# HISTORIC PRESERVATION REVIEW BOARD STAFF REPORT AND RECOMMENDATION

Address: 420 11<sup>th</sup> Street SE () Consent ANC: 6B (x) Concept

Case Number: 21-253 ( ) Demolition

Applicants Esther and Michael Konrad, with drawings by Vaclav Malek, seek concept review for construction of a two-story rear addition on a property located in the Capitol Hill Historic District.

Front elevation of 420 11th St SE, detail of first story replacement window (photo date 10-09-2019)

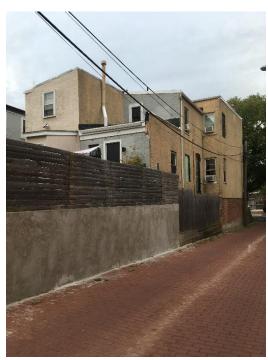
The windows that were in situ prior to the 2019 window replacement were not the original windows. Based on the age of the building, the original windows would have likely been wood multi-pane windows. Six-over-six double-hung sash are most likely, although a two-over-two configuration could also have been possible- both with flat window casings. Per 2305.11 *If the existing windows in an historic building are not historic windows, replacement windows should be consistent with the historic window design if known, or should be consistent with the period of the building and compatible with its general historic character.* The existing windows that were installed without permit do not meet the Regulations. The windows should be replaced, with the required building permit being obtained, with either 6/6 or 2/2 wood windows consistent with the Preservation Regulations and the Board's Window Repair and Replacement Preservation and Design Guidelines.

The outstanding unpermitted windows should be addressed and corrected before new work is permitted. Once the windows have been corrected, the HPO recommends the Board find the project for a rear addition and alterations to be compatible with the Capitol Hill Historic District, with conditions that the parapet walls of the addition roof deck and the front door design be revised, and delegate final approval to staff
